DPO Appeal on DPV Concerning Modeling Chemical Consequence Effects for the Proposed MOX Facility

Overview

Figure 27 Murphy-Campe / ARCON concentration ratios by wind speed
(based upon data from 7 reactor sites in NUREG/CR-6331 on ARCON96)

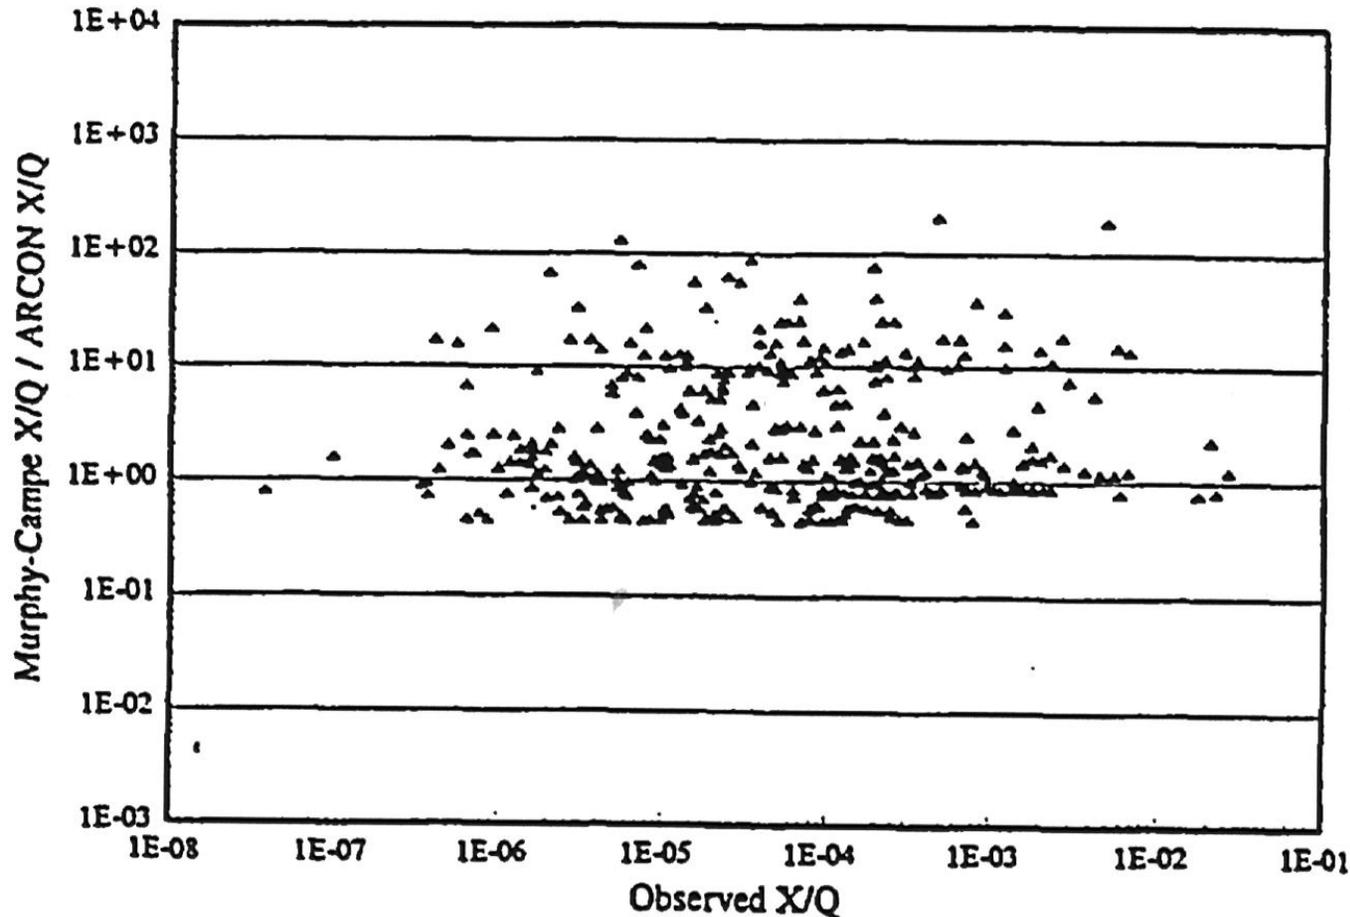
- Applicant Using SRS Wind speed Of 2.2 m/sec

- Which value to use?
